# CITY PLANNING COMMISSION

**APPLICATION:** A. Tentative Map to divide 7 corner lots totaling 1.4+ vacant acres for halfplex development in the Townhouse (R-1A) Zone

B. Special Permit for halfplex development in the R-1A Zone

ADOPTING FINDINGS OF FACT AND  
APPROVING A TENTATIVE MAP FOR  
PROPERTY LOCATED AT VARIOUS CORNER  
LOTS, PARKVIEW ESTATES UNIT NO. 4-  
GLORIA DRIVE AND RUSH RIVER DRIVE  
(P87-077)

## EXHIBIT I ELEVATIONS

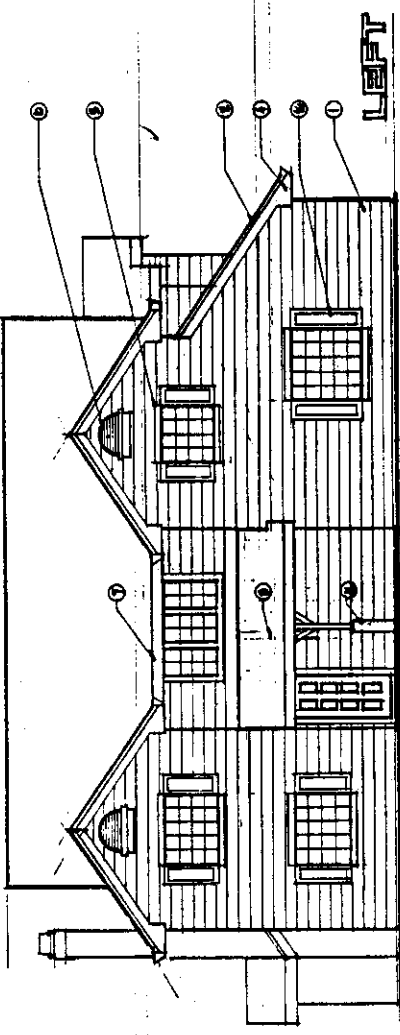
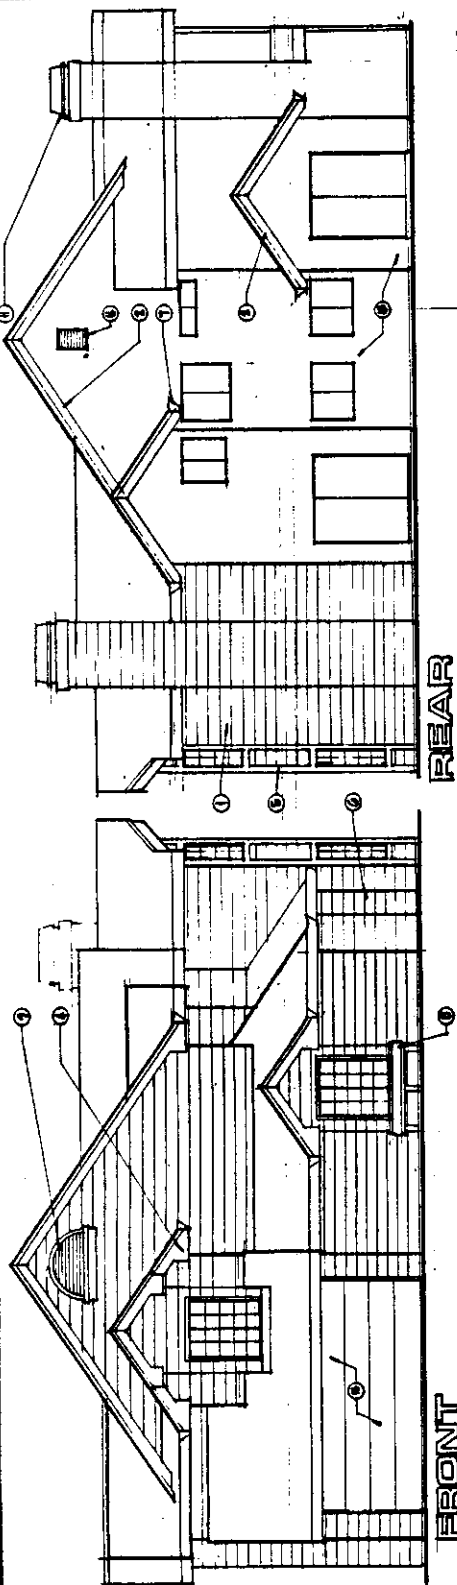
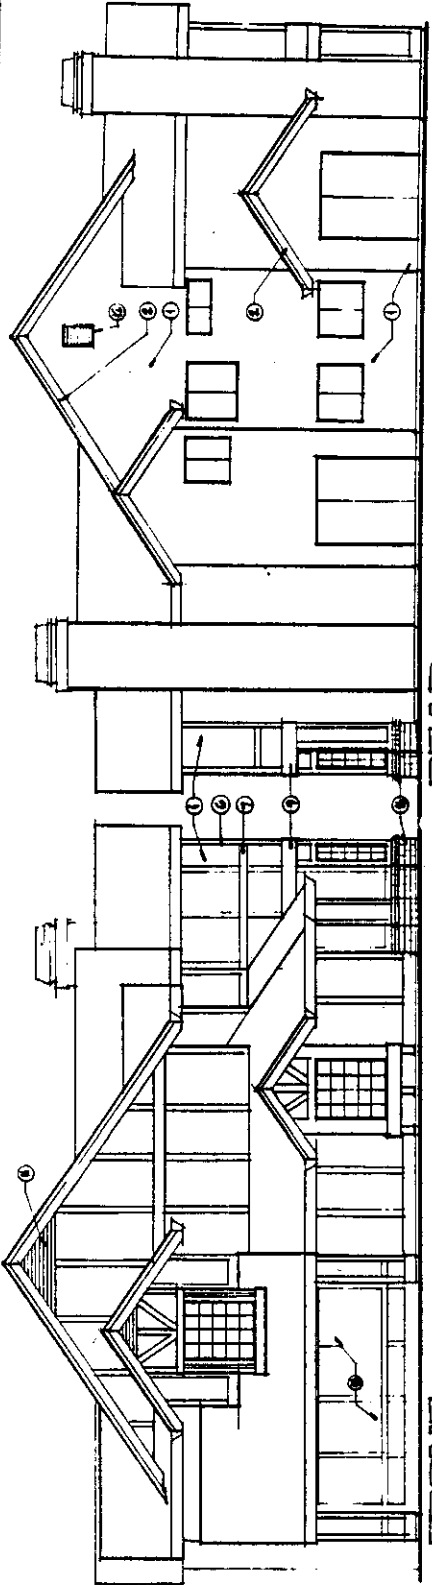
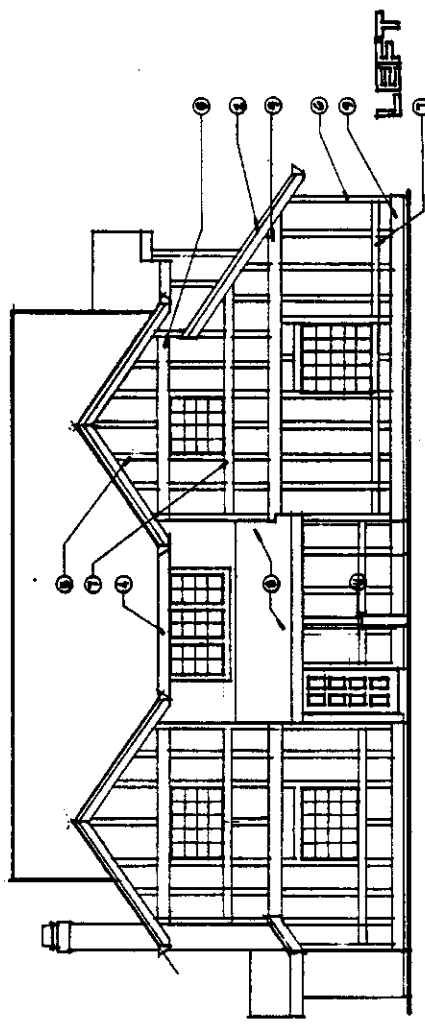
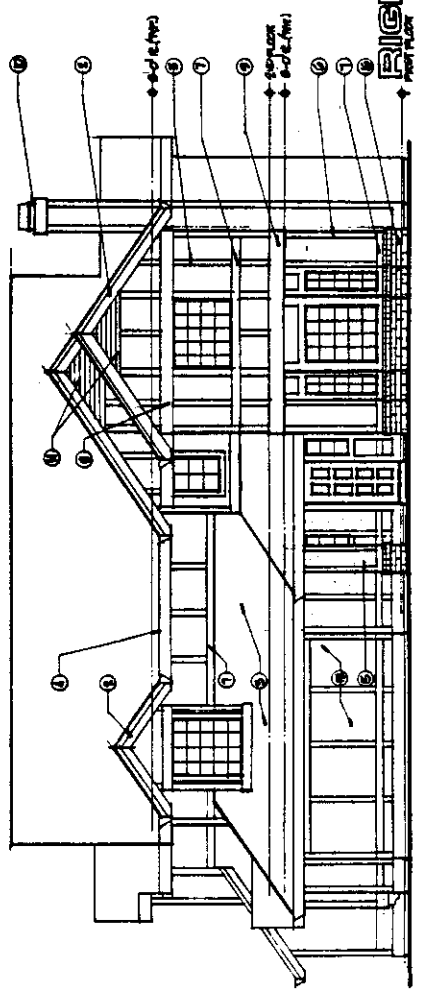
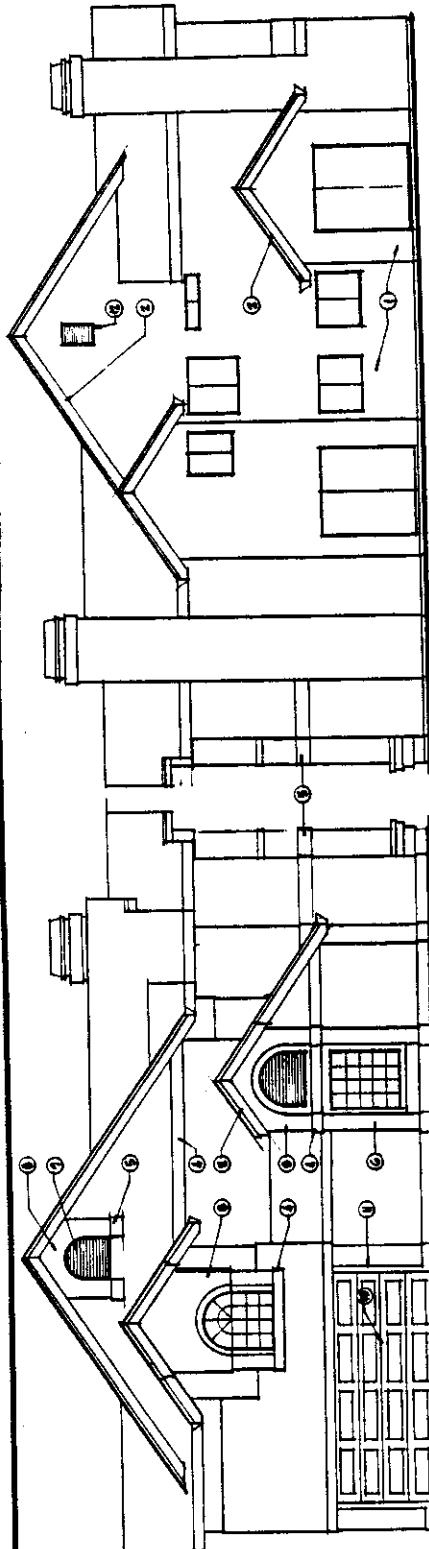
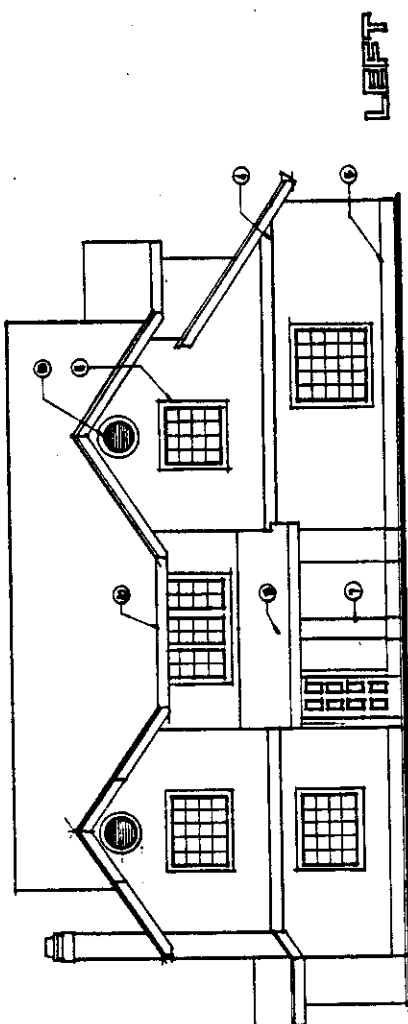
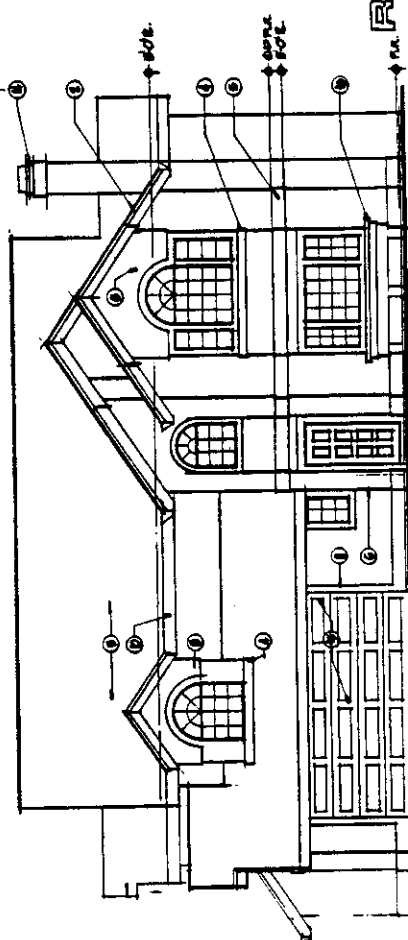
The halfplex units backing up to each other proposed for Lots 7, 8, 14, 15, 22, and 23 have their rear elevations visible from Gloria Drive especially the second story. On the 4 elevations proposed, stucco is the exterior material used on the rear of the units. Staff would support modification to the rear of the units, especially the second story, to be designed similar in accent, trim and architectural amenities as the street frontage. The rear of the seven halfplex units will be visible from Gloria Drive. With modifying the second story rear elevation to continue the architectural style and materials of the front of the units, the proposed halfplex should provide interest and not appear so massive or monotonous as viewed from Gloria Drive.

3. The second story rear elevation shall be modified to be constructed of material similar to the front elevation,. Stucco will not be allowed unless Elevation C and D are used, which are stucco exterior models. Both Elevations C and D have Spanish tile roofing.
